MODIFICATION REQUEST:

***Stage 1 Development, Acute Health
Service Building, Campbelltown Hospital
Lot 6 DP 1058047, Appin and Therry
Roads, Campbelltown
(SSD 5003 MOD 1)***

Modification to condition B3 relating to the
provision of car parking.

Secretary's Environmental Assessment Report
Section 96 of the *Environmental Planning and
Assessment Act 1979*

Figure 2: Campbelltown Hospital Layout (source: www.nearmap.com)

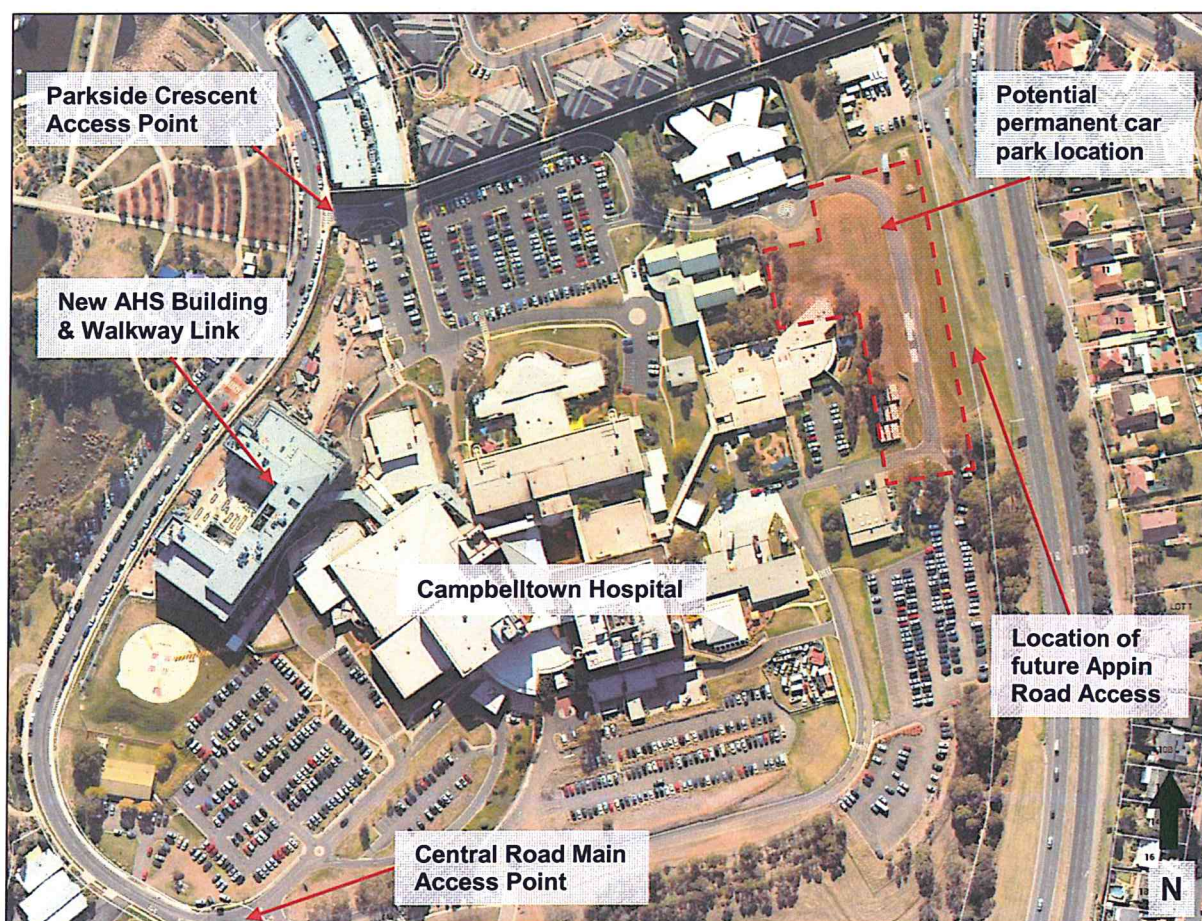
Under the requirements of the current wording of condition B3, details of the proposed location and design of the overflow car park were required to be provided to the satisfaction of the Secretary. Similarly, the location and design of the proposed permanent 75 space car park have not yet been detailed by the applicant. Notwithstanding, Council correspondence recommends the proposed new car park be located in the north-eastern quadrant of the hospital grounds (see **Figure 2**), making use of the future new Appin Road access.

The Department also supports Council's suggested location of the new car park in the north-eastern quadrant of the hospital grounds, adjacent to the future Appin Road access. Using the new access for the new car park would assist in reducing traffic loads within local streets and at existing hospital vehicle entrance points by spreading vehicle traffic around the site (see **Figure 2**).

B3. To ensure that satisfactory car parking is provided, a permanent car park with a minimum capacity of 75 vehicles shall be provided within the north-eastern quadrant of the Campbelltown Hospital campus. Construction of the car park shall take place in conjunction with or prior to the construction of the new vehicle access from Appin Road, or within 12 months from occupation of the Acute Health Services building, whichever comes first.

Details of the location and design of the car park are to be provided to the satisfaction of the Secretary or her nominee prior to the construction of the car park.
